# Campo Del Sol Phase 3

City Plan Commission — August 28, 2025 **REVISED**

<b>CASE NUMBER/TYPE:</b>	<b>SUSU25-00071 – Major Preliminary</b>
<b>CASE MANAGER:</b>	Myrna Aguilar, (915) 212-1584, <a href="mailto:AguilarMP@elpasotexas.gov">AguilarMP@elpasotexas.gov</a>
<b>PROPERTY OWNER:</b>	Franklin Mountain Communities, LLC
<b>REPRESENTATIVE:</b>	SLI Engineering, Inc.
<b>LOCATION:</b>	West of McCombs St. and North of Gateway South Blvd. (District 4)
<b>PROPERTY AREA:</b>	90.176 acres
<b>VESTED RIGHTS STATUS:</b>	Not Vested
<b>PARK FEES:</b>	Park Fees Not Required
<b>EXCEPTIONS/MODIFICATIONS:</b>	Yes, see following section
<b>ZONING DISTRICT(S):</b>	GMU (General Mixed Use)

**PRELIMINARY PLAT**

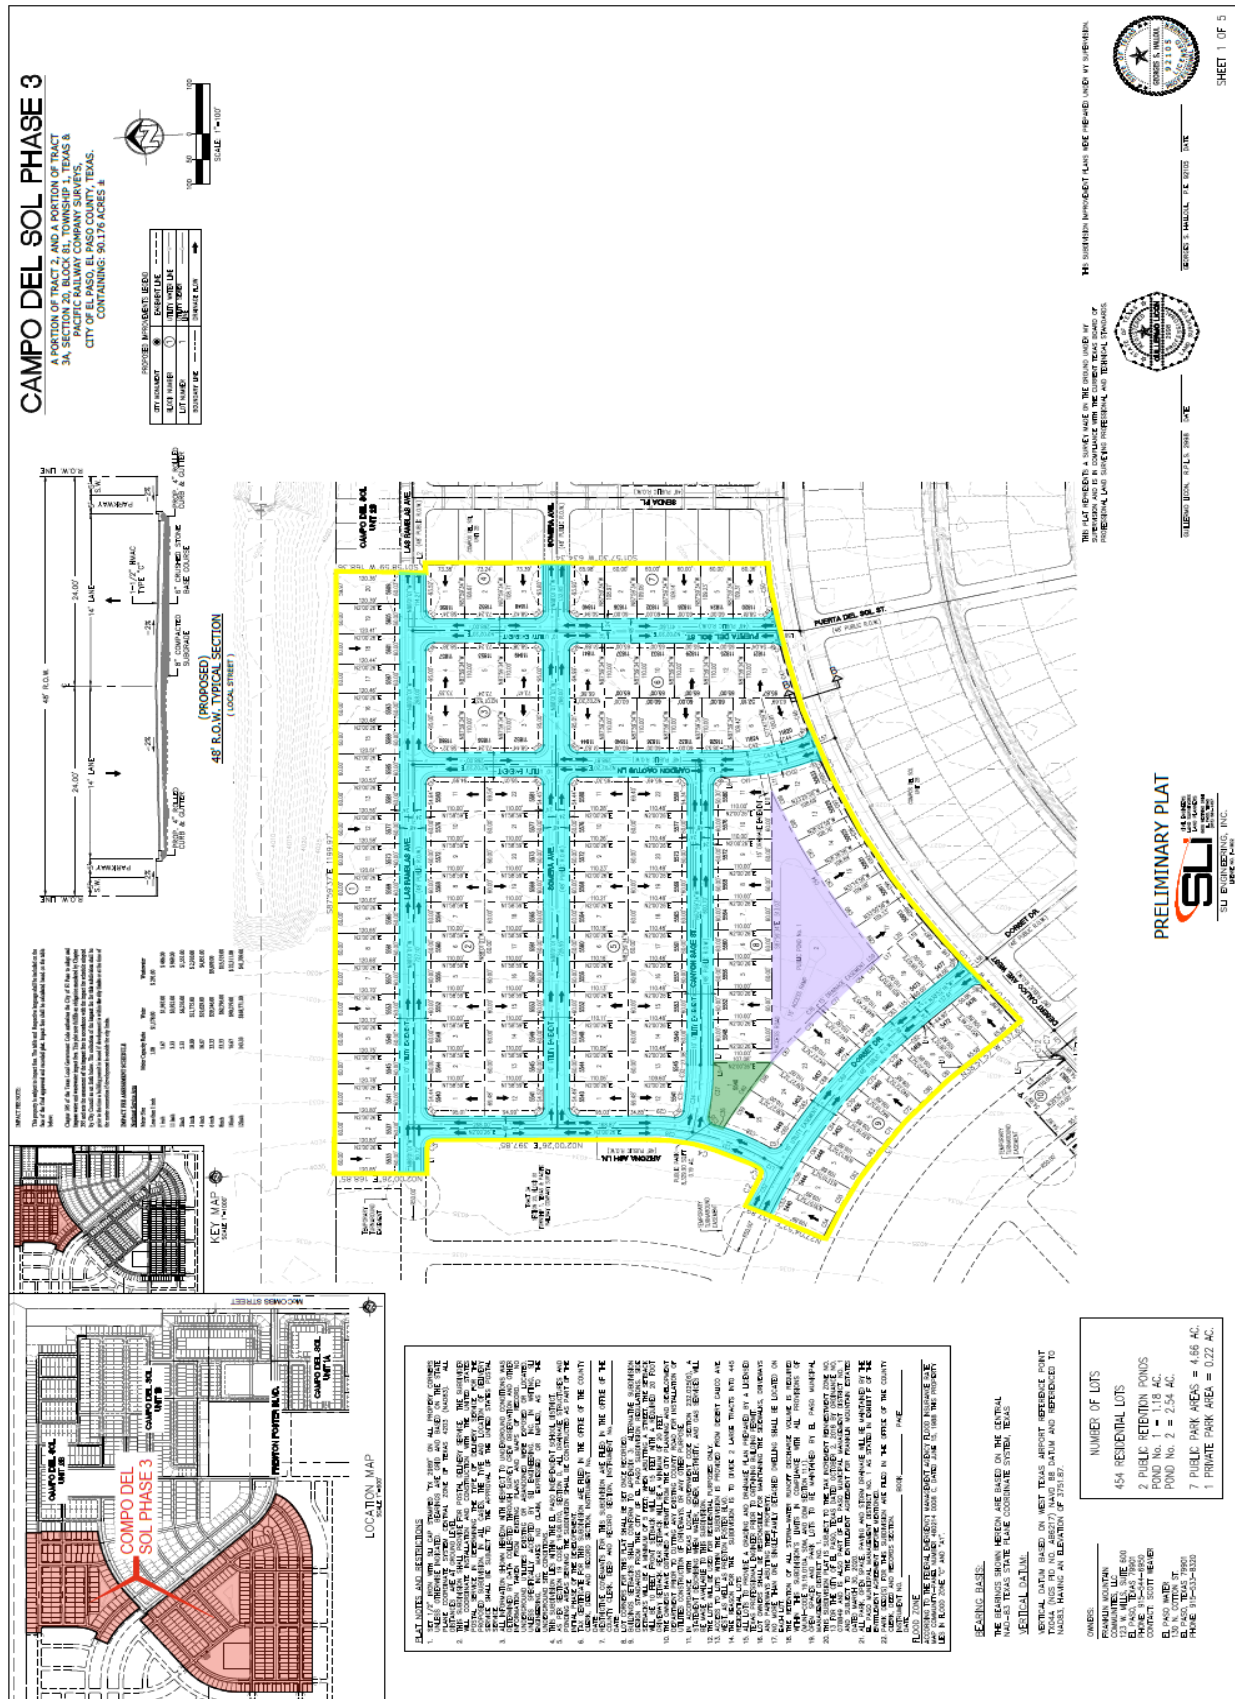
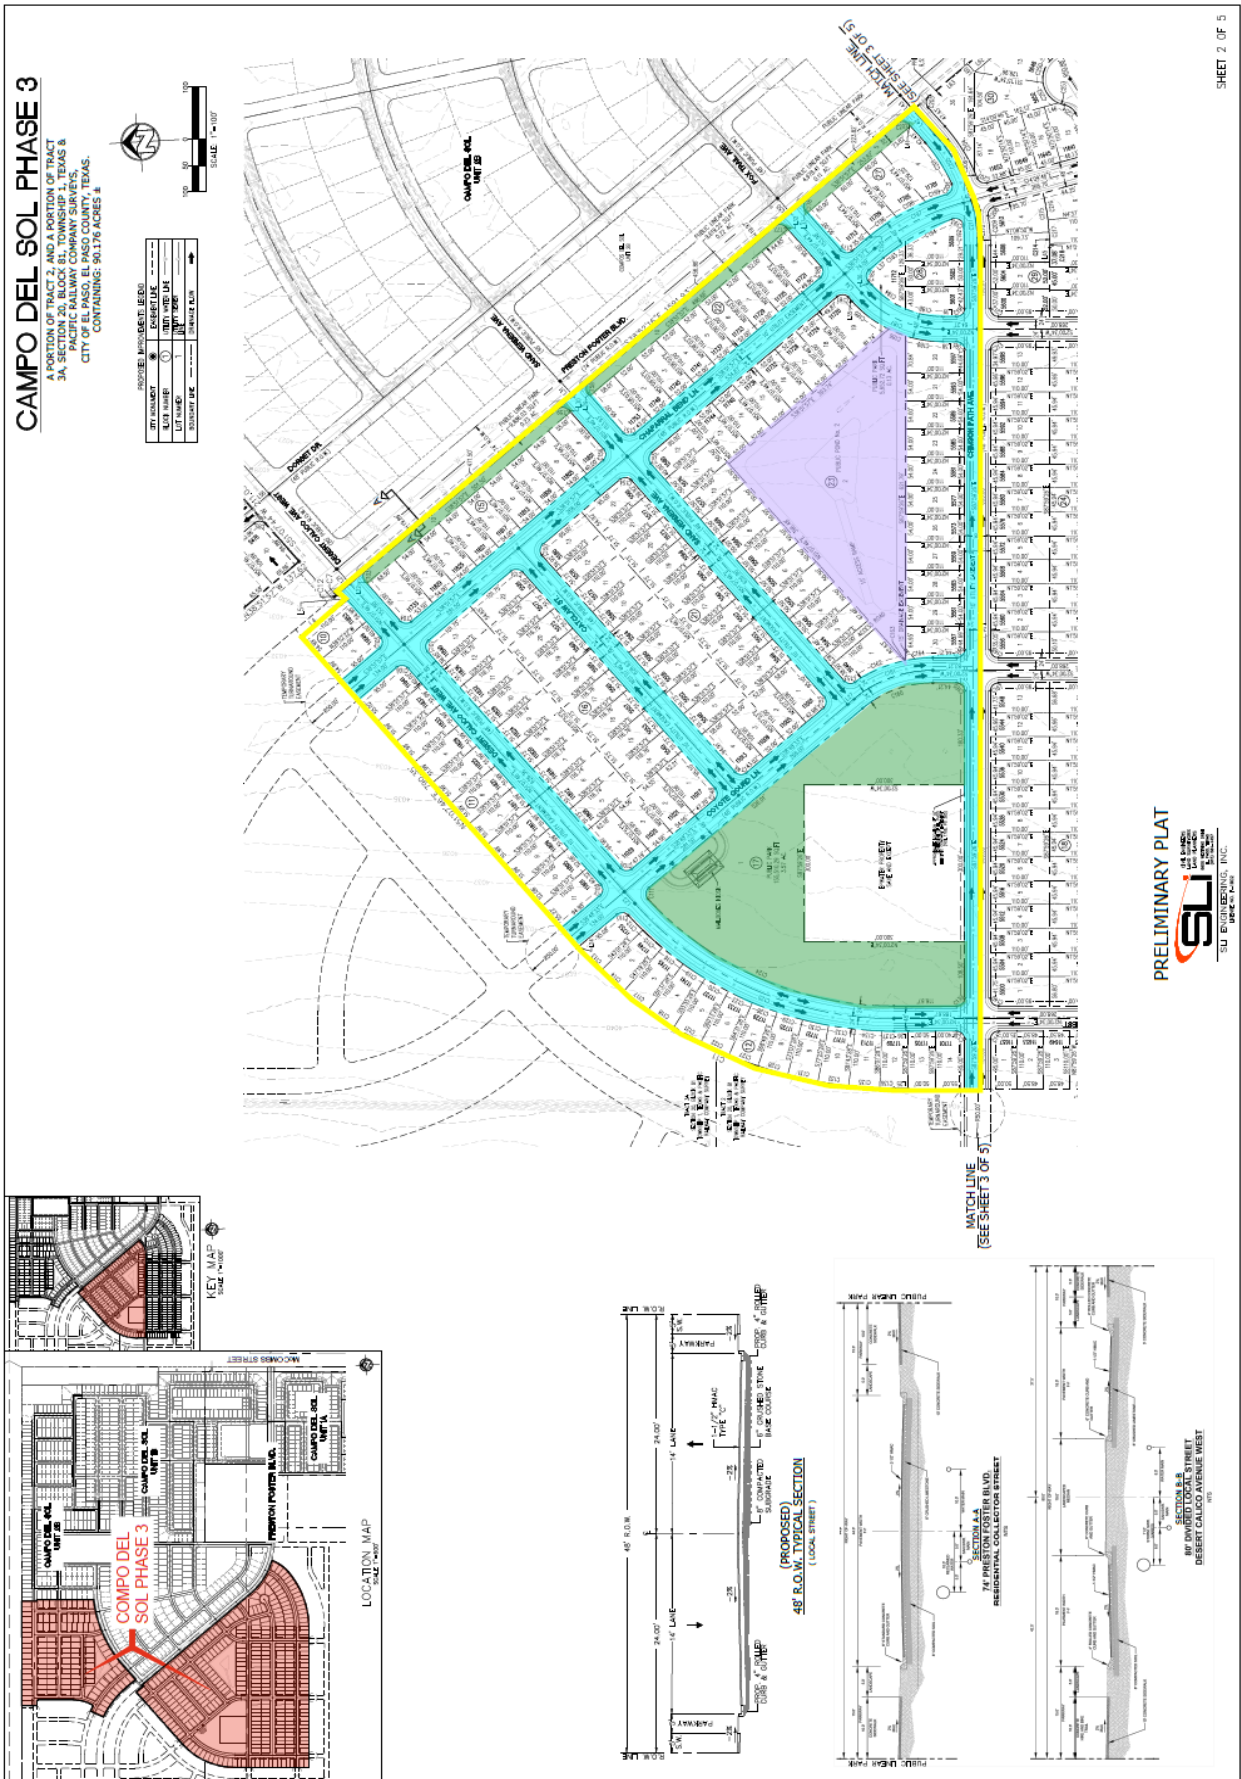
1. Provide subdivision improvement plans to Land Development.
2. Show proposed drainage flow patterns on the preliminary plat and identify the storage location for all storm water runoff.
3. Extend contour lines of the proposed subdivision, and two hundred feet outside and abutting the subdivision.
4. Verify pond (Lot 2, Block 8) access road width is at least 15’ wide the entire length.
5. Dimension utility easements for all lots.
6. The report print-out of the mathematical closure is ok.

EPWater requests a 20-foot PSB easement within Lot 35, Block 30 to accommodate the existing 24-inch reclaimed water main.

- On intersection of Desert Calico Ave & Preston Foster Blvd., westward of Desert Calico is 80-foot ROW and eastward is 48-foot ROW. Roadway alignment shall be implemented. What is the proposal designs to accommodate this issue?
- There are streets which we highly recommend installing or constructing traffic calming devices since the concern in some of the streets are to encourage speeding.
- As per city ordinance 19.03.010 Purpose, Exceptions and Effect can be implemented on the traffic calming for the safety of citizens that are going to living in the subdivision.
- As per city ordinance 19.15.020 Subdivider responsibility can be implemented on traffic calming for streets being constructed on subdivision
